## Town of Underhill

### Zoning Violation

#### Discrepancies in Warren Creek Extension Shared Infrastructure

November 28, 2016

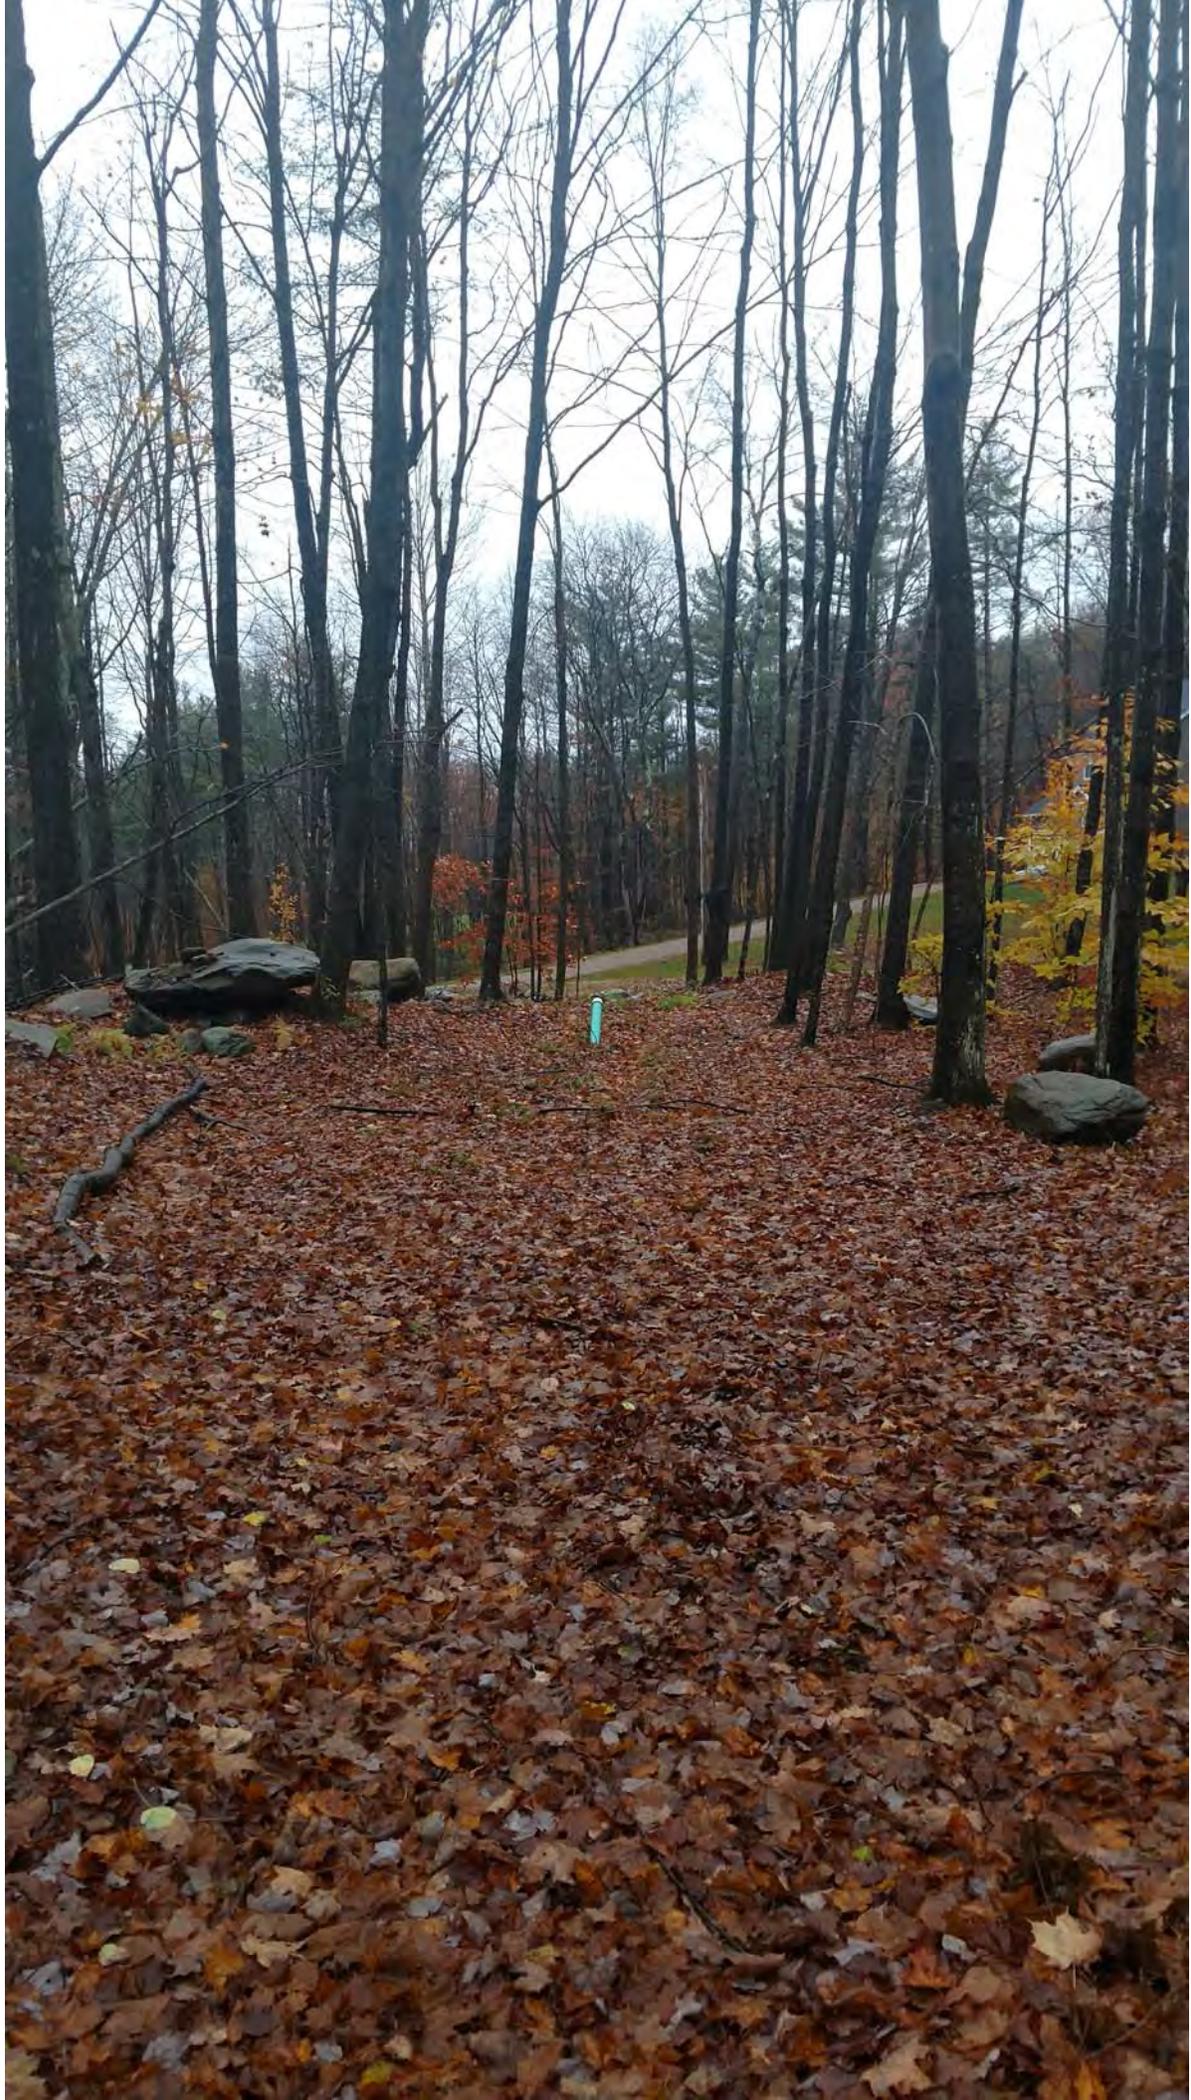
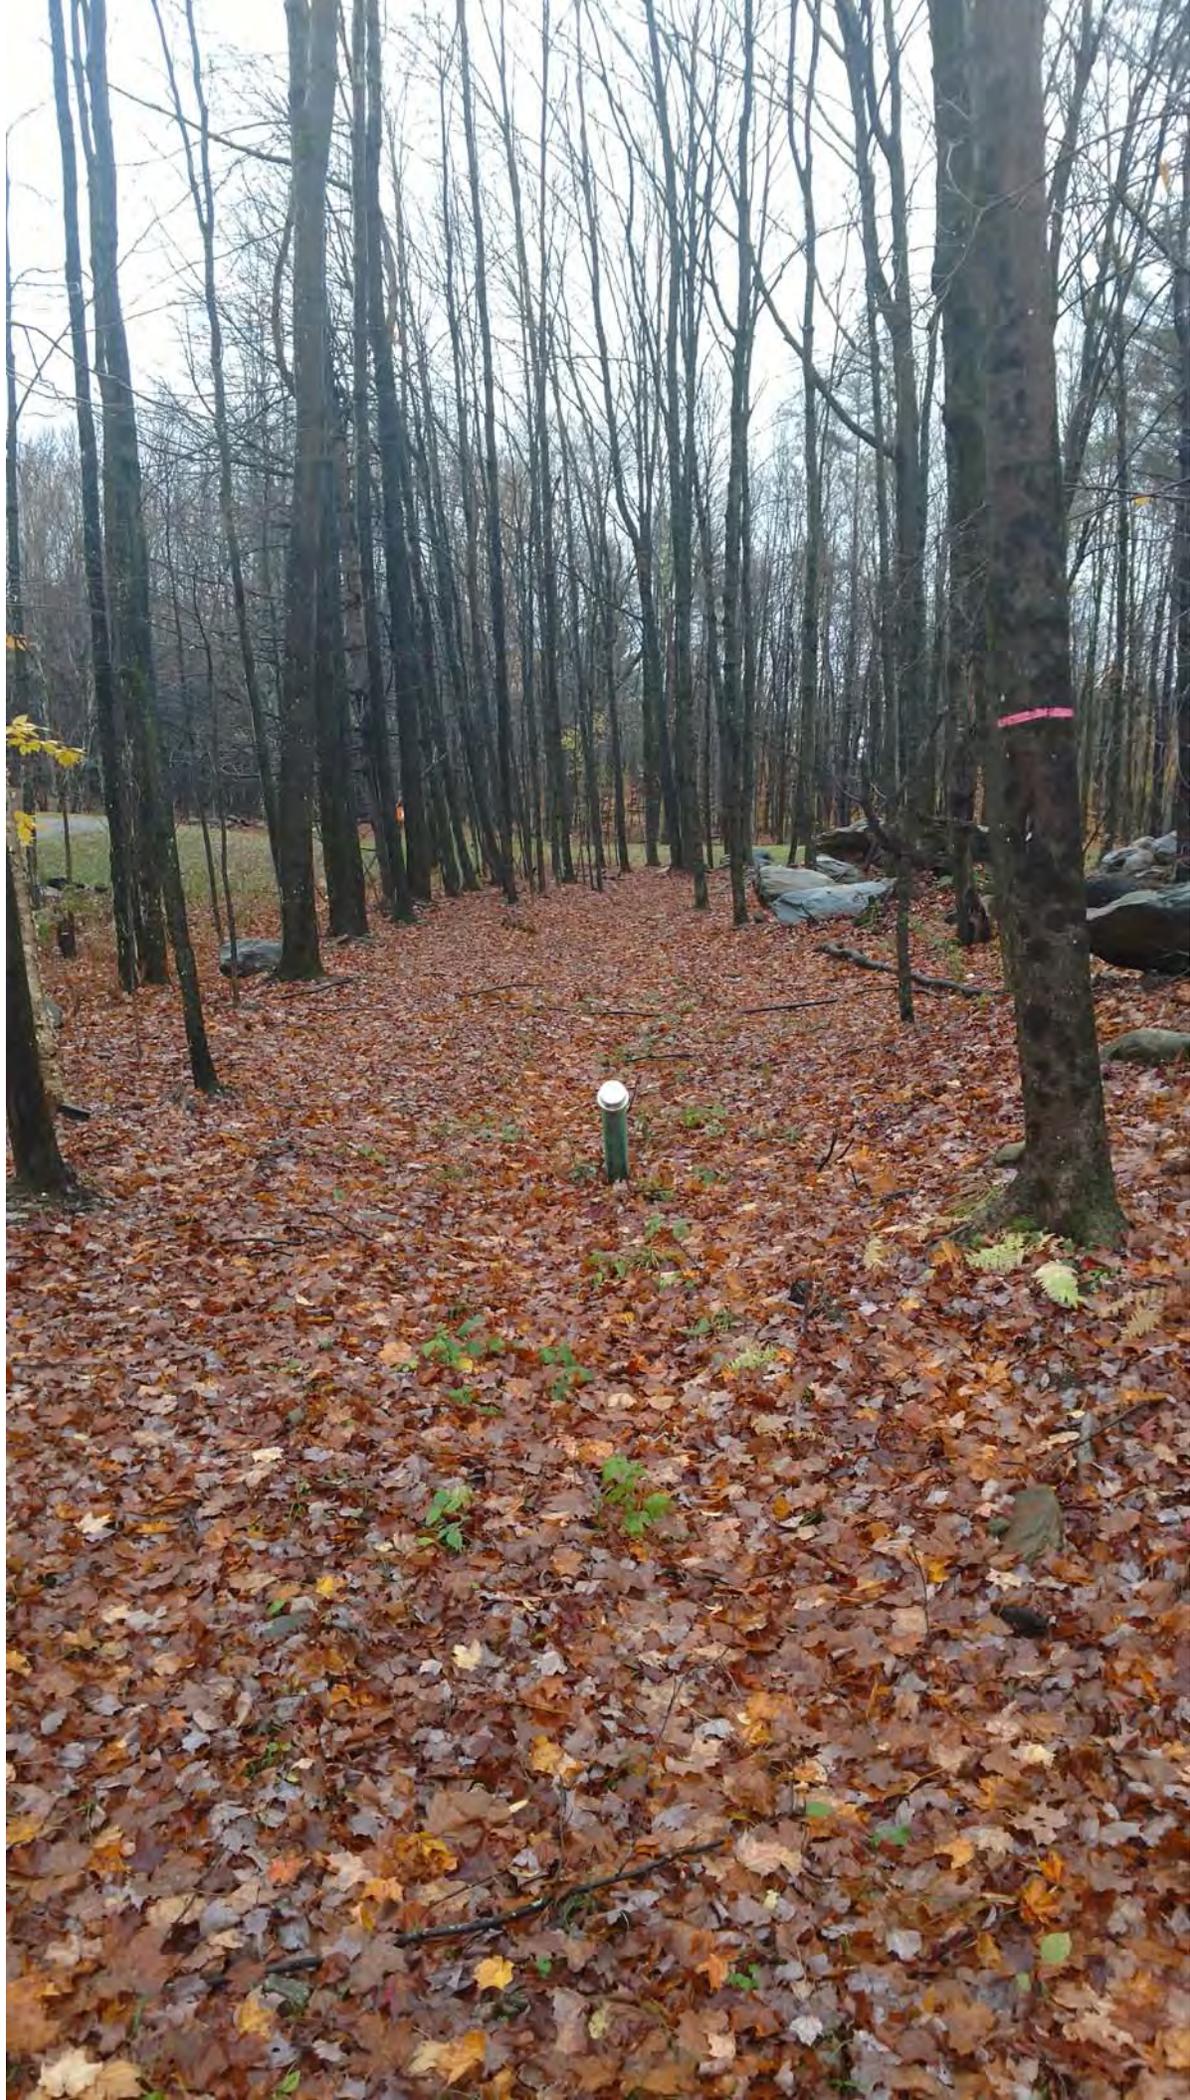
I agree with the location of the disposal fields as depicted on the site plan dated June 27, 2016 prepared by McCain Consulting, Inc. However it appears that the sewer pipe coming from Lot 3 to the disposal field was not constructed within the easement area. I have based this upon the direction of the cleanout, which is near the Lot 3 and 4 boundary, and the direction of the pipe coming into the distribution box as well as the evident path through the woods. See photographs attached. The only sure way to know would be to run a locator beacon down the pipe.

I located the existing well locations, as shown. The design locations were scaled from the McCain drawings. There are irregularities in the McCain drawings, as far as the scale is concerned, so those are shown as approximate only.

These issues all appear to be fairly minor in nature and could be easily resolved by submitting amended drawings to the State, if necessary, and by exchanging deeds between the owners of Lot 3 and Lot 4 to reflect a revised easement location.
